Docket Item #11
BAR CASE # 2007-0002

BAR Meeting
February 7, 2007

ISSUE: Addition and alterations

LOCATION: 833 South Lee Street

Figure 1 - Proposed east elevation

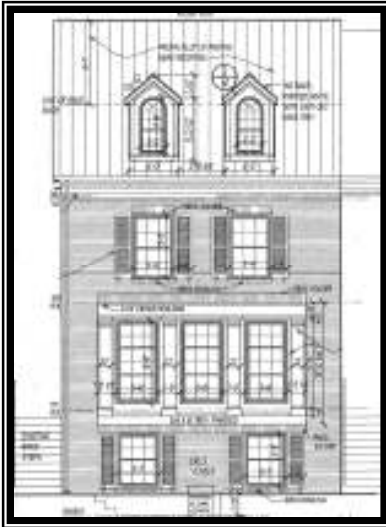
Staff has additional concerns about a number of details. For example, the recessed ganged windows on the front elevation are awkward and are not a part of the vocabulary of design elements found in Yates Garden. Similarly staff also finds the proposal for awning style windows fronting on Green Street introduce an awkward element.

While Staff does believe that an addition to this property could be achieved, Staff recommends that the applicant restudy the approach for the addition, and eliminate the addition to the east façade, to maintain the existing pattern of facades along South Lee Street.

Staff recommends deferral of the application for restudy of the massing approach to the additions and the design details.
